Item Name: Crosstube Turning Detail

DART AEROSPACE LTD		Work Order:	93994
Description: Crosstube Assembly (205/212/412 High Fwd)		Part Number:	D212-664-141
Inspection Dwg: D212-664-141 Rev: D		Page 1 of 2

DRAWING NO. D212-664-141	TITLE XTUBE ASSY (205/212/412 HI FWD)	REV. D	DART AEROSPACE LTD ENGINEERING ORDER		D.E.O. NO. D212-664-141-D-1	SHEET NO. SHEET 1 OF 2	SCALE NTS
DRAWN	CHECKED	MFG. APPR.	APPROVED	DE APPR.			
DATE 11.04.07	DATE 11.07.11	DATE 11.04.12	DATE 11/04/12	DATE 11.04.12

DRAWING NO. D212-664-141	TITLE CROSSTUBE ASS'Y (205 HI FWD)	REV. D	DART AEROSPACE LTD ENGINEERING ORDER		D.E.O. NO. D212-664-141-D-2	SHEET NO. SHEET 1 OF 1	SCALE NTS
DRAWN <i>UP</i>	CHECKED <i>ASS</i>	MFG. APPR. <i>AB</i>	APPROVED <i>MD</i>		DE APPR. <i>HH</i>		
DATE 11.07.15	DATE 11.07.20	DATE 11.07.21	DATE 11/07/21		DATE 11.07.21

**D212-664-141/-141B
ASSEMBLY DETAIL**

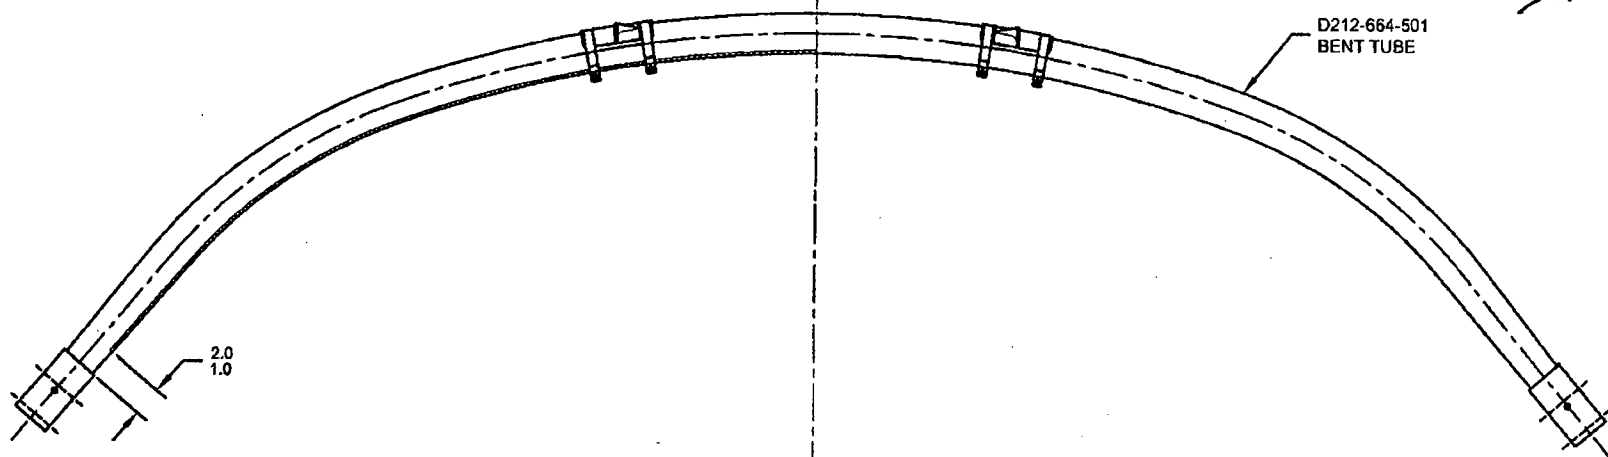
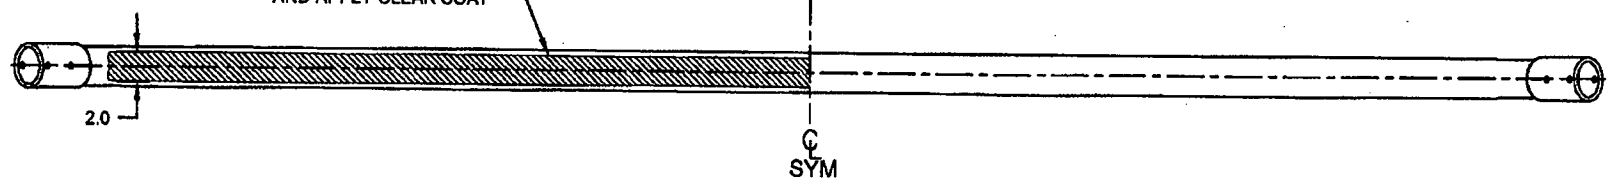
PURPOSE:

ADD AN INSPECTION WINDOW TO UNDERSIDE OF CROSSTUBE.

CHANGE:

NOTES 2 OF SHEET 1 IS AMENDED AS FOLLOWS:

IS:

- 2) FINISH: CHEMICAL CONVERSION COAT PER DART QSI 005 4.1
PRIME INSIDE AND OUTSIDE PER DART QSI 005 4.2
MASK UNDERSIDE OF CROSSTUBE AS SHOWN (HATCHED AREA) AND
PAINT OUTSIDE PER DART QSI 005 4.2
REMOVE MASKING AND APPLY CLEAR COAT

WAS:

- 2) FINISH: CHEMICAL CONVERSION COAT PER DART QSI 005 4.1
PRIME INSIDE AND OUTSIDE PER DART QSI 005 4.2
PAINT OUTSIDE PER DART QSI 005 4.2

MASK AREA PRIOR TO PAINTING,
REMOVE MASKING AFTER PAINT
AND APPLY CLEAR COAT
